City of Detroit
Inter-Departmental Communication

RE: Petition No. 1358
Requested Encroachment Into Russell At 2727 Russell (With Outdoor Seating)

PROVISIONS FOR ENCROACHMENT For Petition 1358

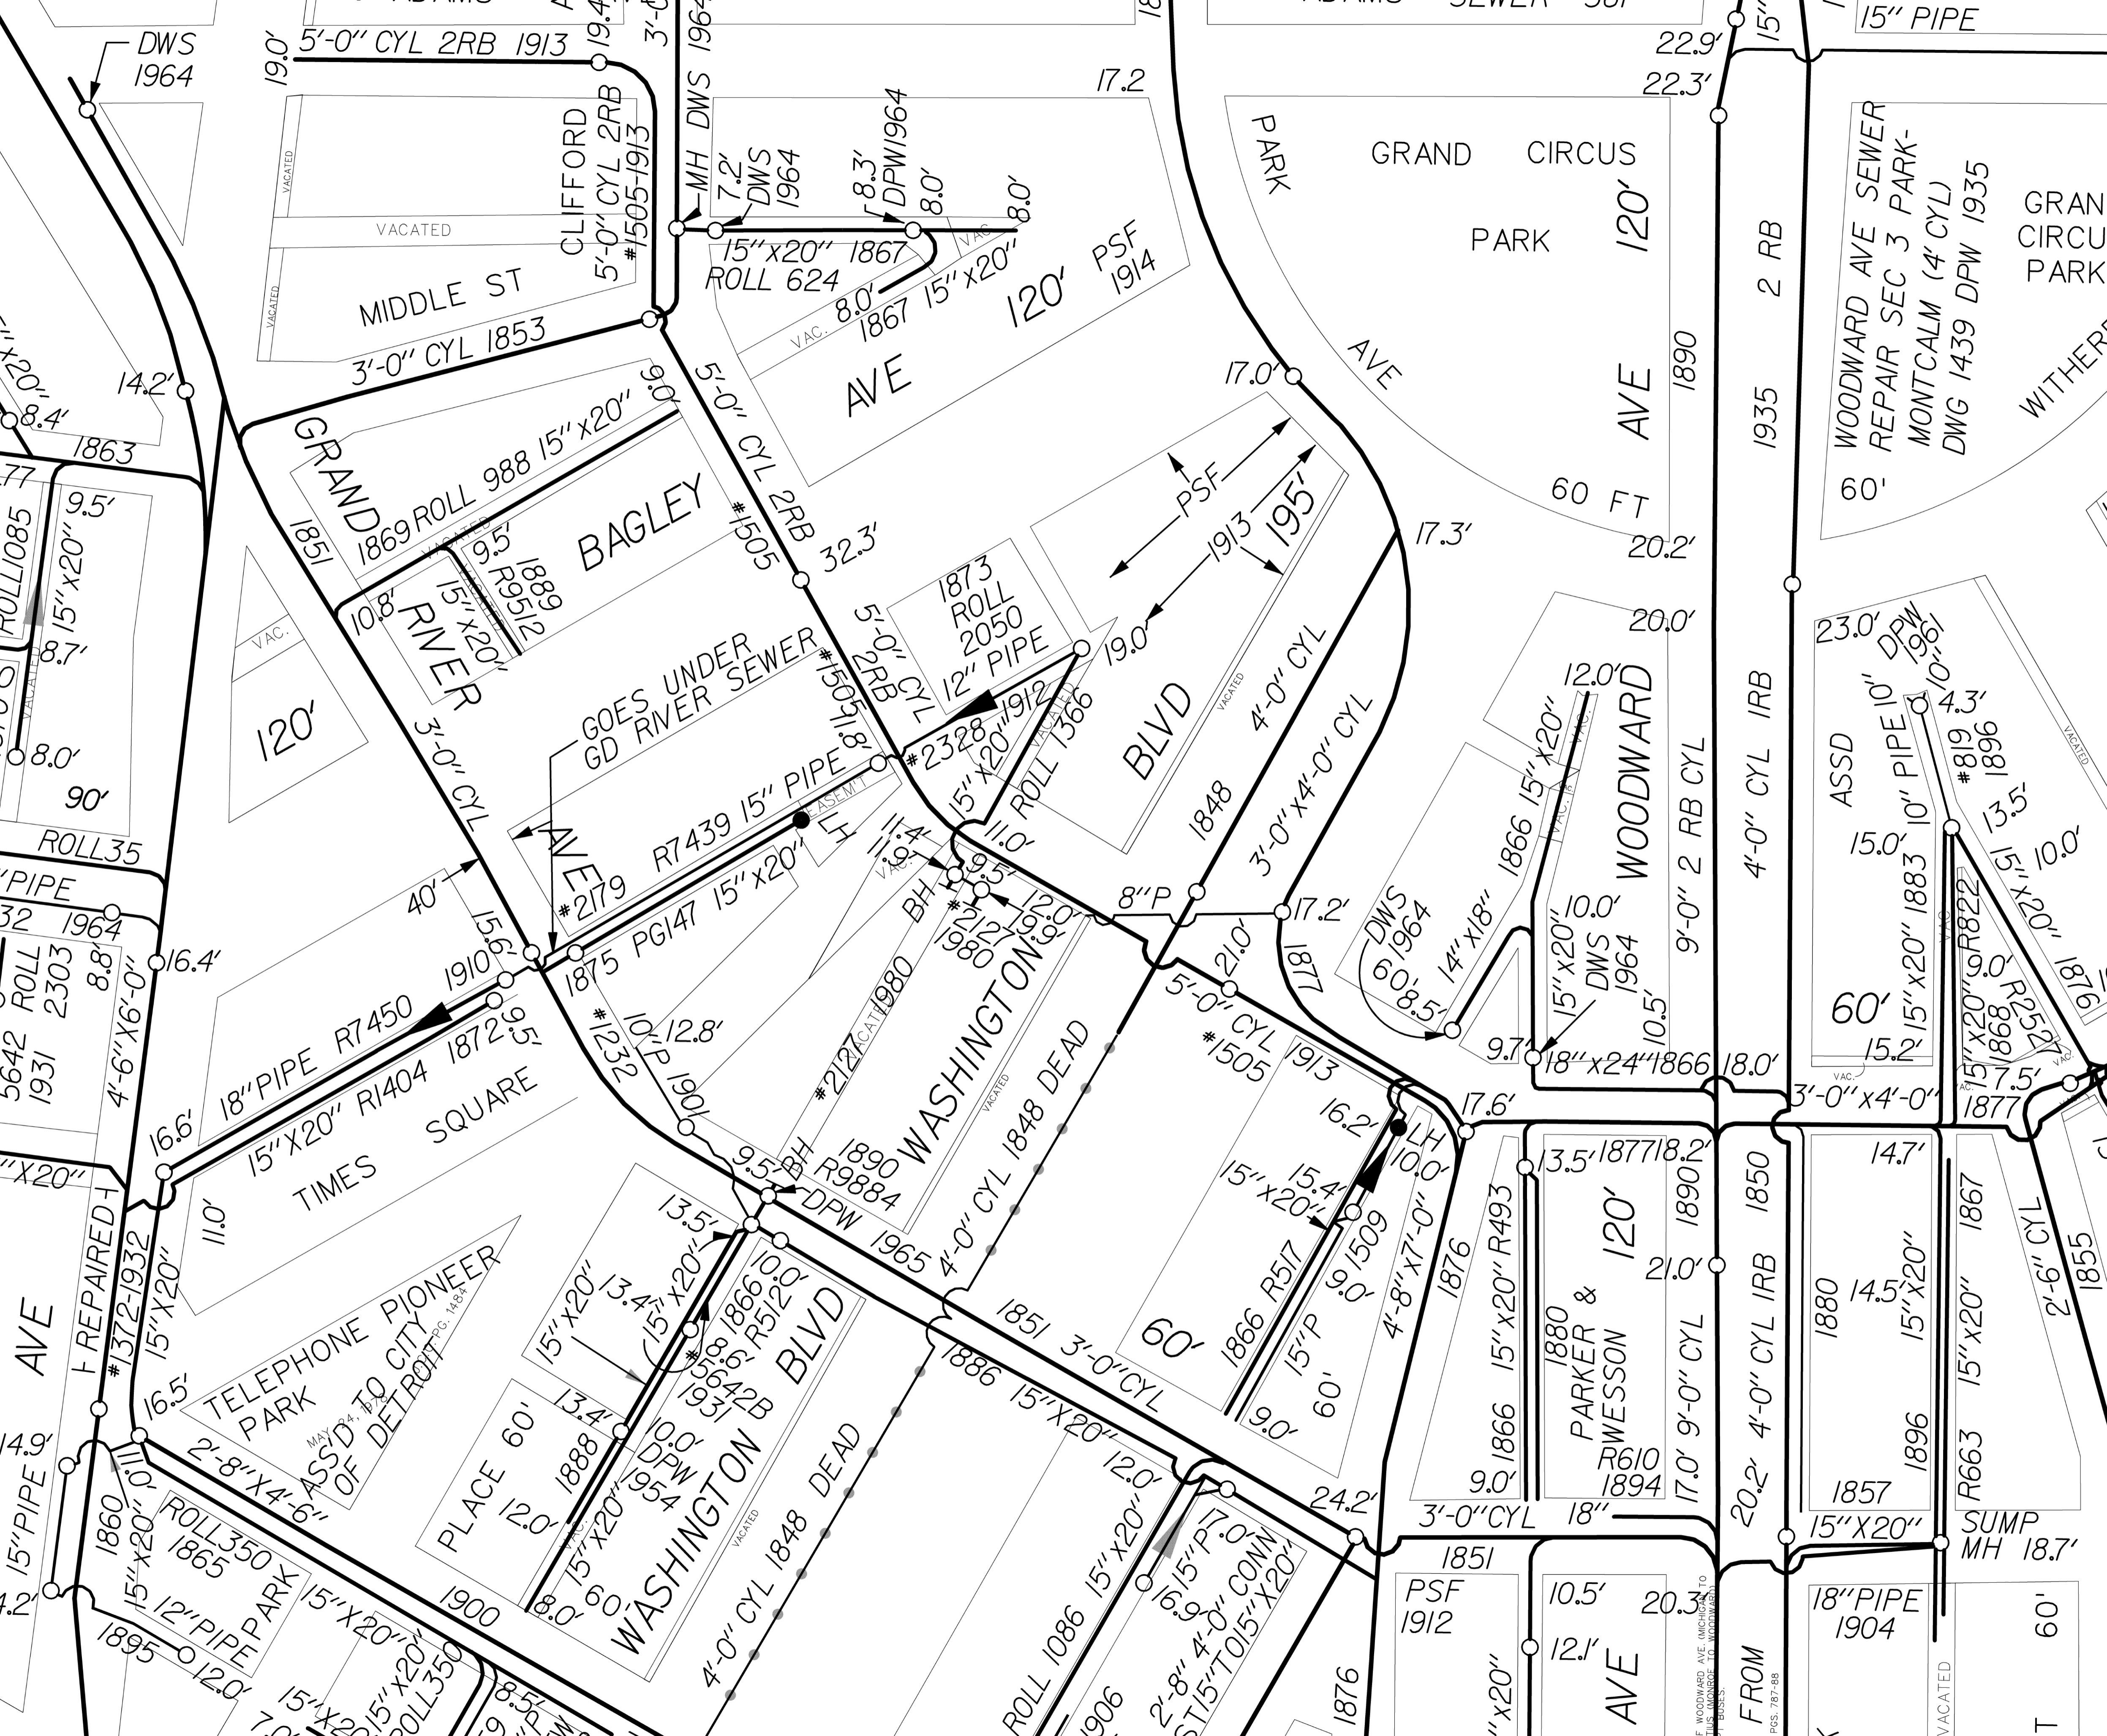
- Our records indicate that there are water mains and sewers which are located in the vicinity of the proposed project limits.
- It is DWSD's requirement that any proposed utility crossing DWSD water mains or sewers perpendicularly must maintain a minimum of 18 inches vertical clearance. Also any proposed utility running adjacent to DWSD water mains and sewers must maintain a minimum of 5 feet lateral clearance including any conduit and/or manholes walls. No utility is allowed to run along the top of the water main or sewer.

- There are possibilities of several water and sewer service lines crossing in the vicinity of proposed work, field verify their location and depth to maintain our required clearance.

- Detroit Water and Sewerage Department (DWSD) prohibits the use of heavy construction equipment (bulldozers, backhoes, extremely large rollers, etc.) and or storage of building material directly over or near our mains or sewers. DWSD also prohibits the use of cranes and balls or hydraulic rams for pavement removal where the DWSD facilities are involved. If the water main or sewer facilities are broken or damaged as a result of any action on the part of the contractor, then the contractor shall be liable for all costs incidental to the repair of such broken or damaged water main/sewer facilities and appurtenances. The contractor shall waive all claims for damages under such circumstances.

- For any proposed work that involves DWSD utilities (water mains and/or sewers), an approval and a permit is required from DWSD before the commencement of work.
